VOGTLE ELECTRIC GENERATING PLANT
UNIT 1
INSERVICE INSPECTION PROGRAM
ISI-P-006
Revision 2 Summary of Changes

VEGP-1

RR-21

BRANCH CONNECTION CONFIGURATIONS
ATTACHMENT 2

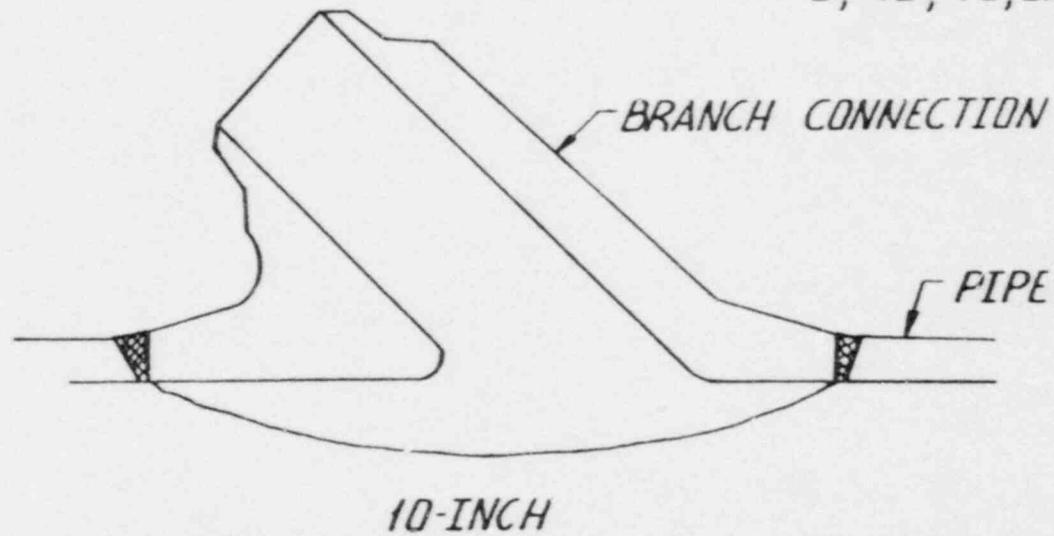
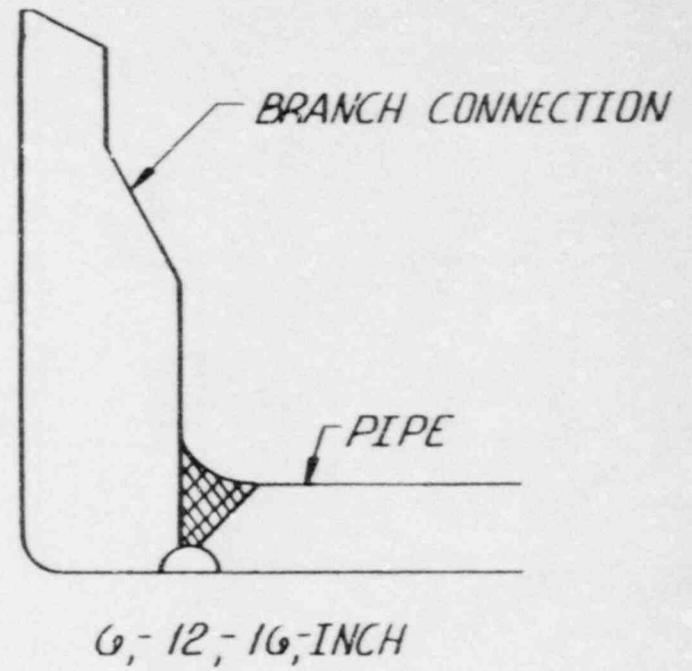
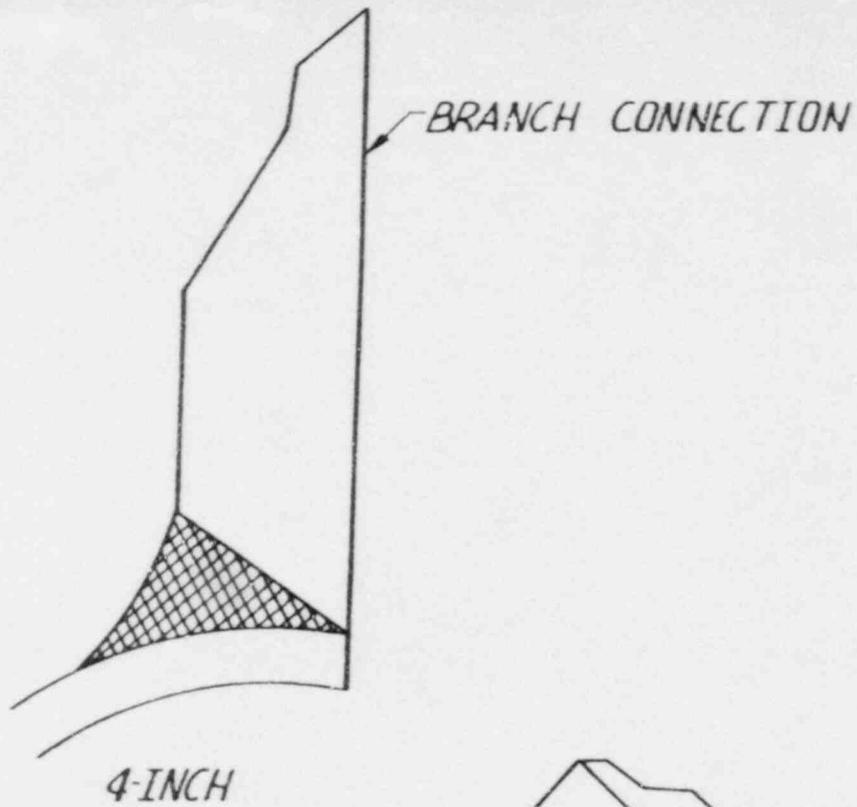
Two basic weld configurations are used for the branch connection designs on the main loop piping. The 4-inch branch connections were installed using a "set-on" weld design, while the 6-, 10-, 12-, and 16-inch branch connections were installed using a "set-in" design. (See Attachment 2 for configuration.)

Examination of the 4-inch branch connection welds from the main run of piping using the 1/2 node RL wave is not possible due to the geometry of the "set-on" configuration. However, partial coverage of the 6-, 10-, 12-, and 16-inch branch connection welds from the main run using the 1/2 node RL technique is possible because of the "set-in" configuration. Approximately 50 percent of the code required volume (one beam direction only) for the 6-, 10-, 12-, and 16-inch branch connection welds can be examined using this technique.

To increase coverage and provide two-directional coverage, scanning from the branch connection side will also be used where possible. The forged stainless steel material used in all but the 10-inch branch connections allows the use of shear wave ultrasonic techniques, however the geometry of the fittings still presents problems in obtaining Code required coverage.

Based on plots and calculations, it was determined that the only feasible examination from the branch connection side would be a shear wave technique from the taper of the fitting. This technique will rely on the ability of the shear wave to reflect off of the inner wall of the fitting bore, and should result in approximately 80 percent of the required volume being examined on the 4-inch branch connections.

The fitting side of the 10-inch branch connection is cast stainless steel, this precludes the use of a shear wave technique. Also, due to the geometry of the part examination from the branch connection side using the 1/2 node RL technique is not feasible.

When examinations are conducted from the branch connection side, calibration blocks will be fabricated to match the actual configuration of the components to the extent practical. Reflectors would be machined into these "mockups" in the appropriate locations. In cases where it is determined that one size mockup would provide adequate representation for two branch connection sizes, only one calibration block will be fabricated. For example, only one mockup would be provided for the 12- and 16-inch branch connections if it is determined to provide appropriate calibration.

The Code required surface examination will be performed. An ultrasonic examination will be performed to the extent possible as defined above.

STEAM GENERATOR PRIMARY
INLET-OUTLET NOZZLE SECTION

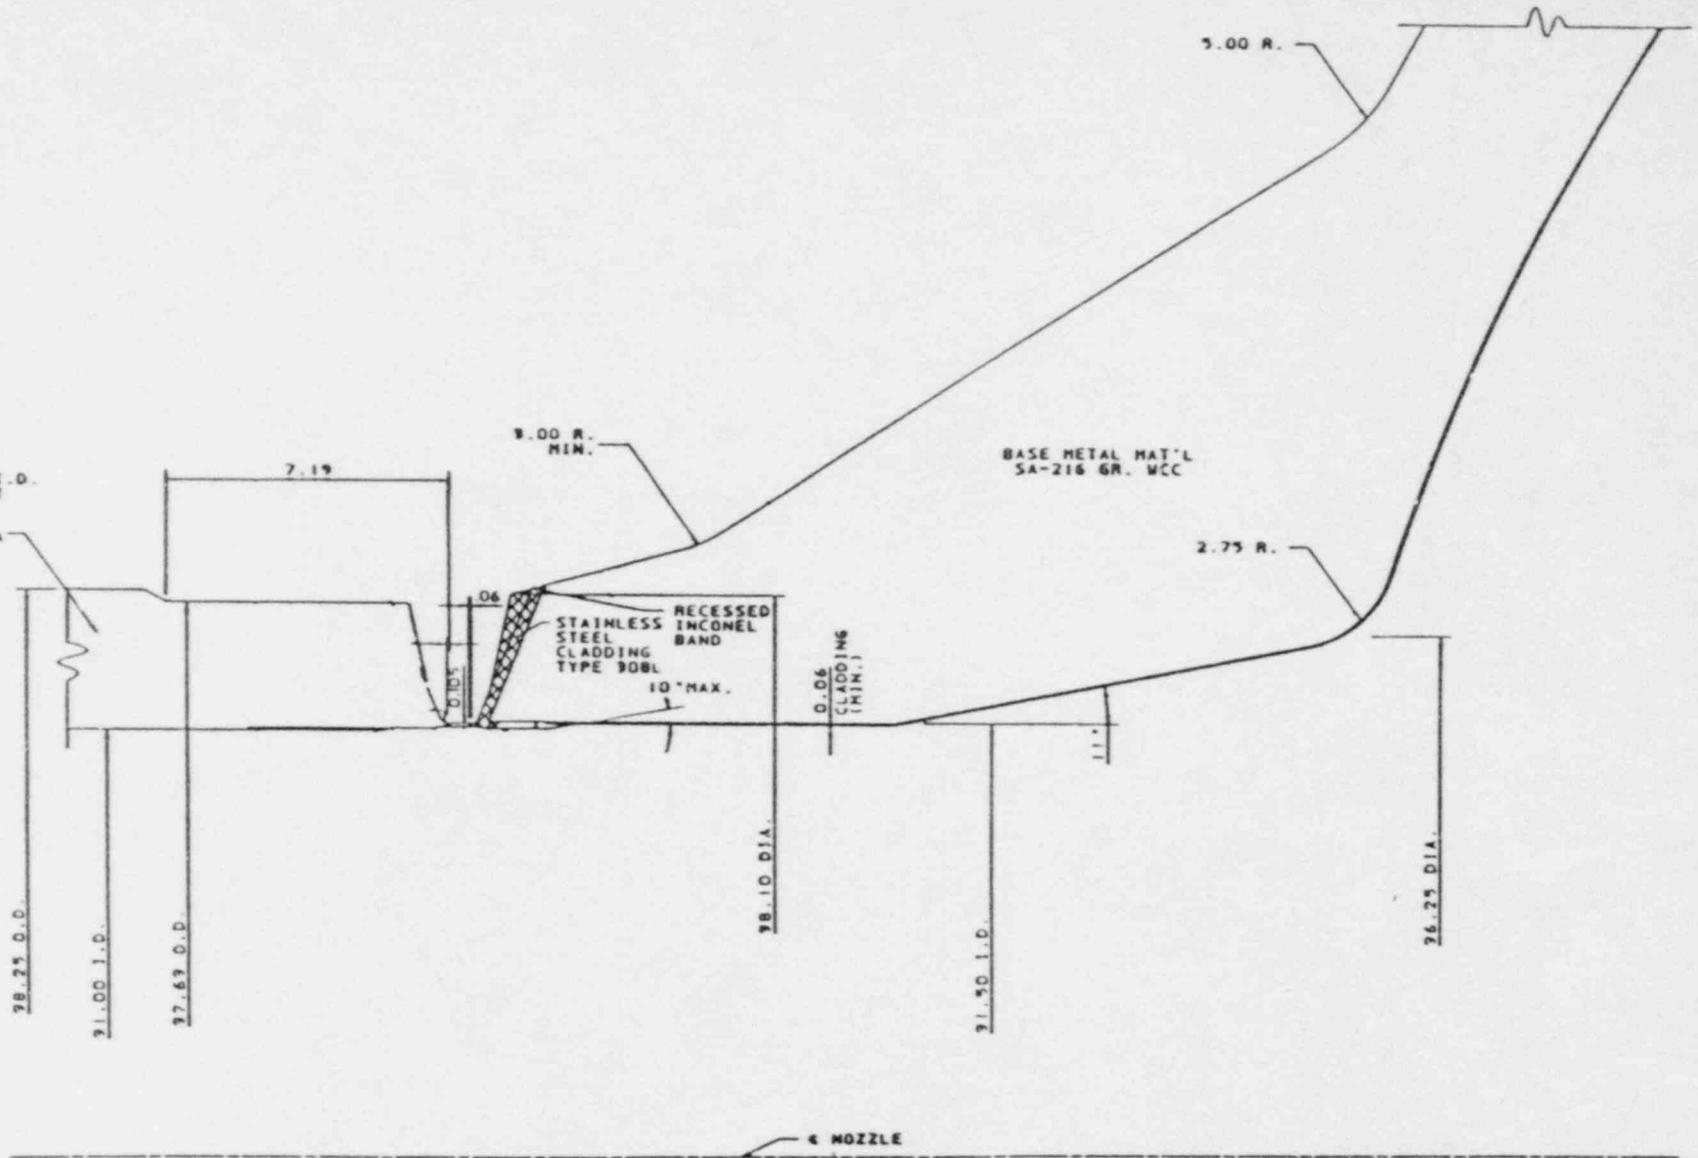
ASME Code Item No. B3.140 Category B-D, requires volumetric examination of the nozzle inside-radius section for steam generator nozzles. Figure IWB-2500-7 shows the applicable examination volume. Relief is requested from accomplishing this examination for the inlet and outlet nozzles on all steam generators.

The steam generator primary side nozzles are integrally cast as a part of the channel head. The steam generator nozzle inner radiused section cannot be volumetrically examined from the outside of the nozzle or channel head because the rough, as-cast contact surface is not suitable for ultrasonic coupling, and the geometrical configuration requires an excessively long test metal distance resulting in high ultrasonic attenuation. The inside of the nozzle and channel head areas are covered with cladding in the "as-welded" condition; therefore, meaningful volumetric examination cannot be performed from the "as-welded" surface. Even with proper preparation of the inside surface for volumetric examination, an adequate examination of the area of interest (base metal just below the cladding) could not be achieved due to the resulting ultrasonic response at the clad-to-base metal interface. A section drawing of the steam generator primary inlet and outlet coolant nozzle has been provided.

The inside surface of each steam generator primary side nozzle inner radiused section will be visually examined to the extent practical. The examination area will include the inner radius surface region shown in ASME Section XI, Figure IWB-2500 to the extent practical.
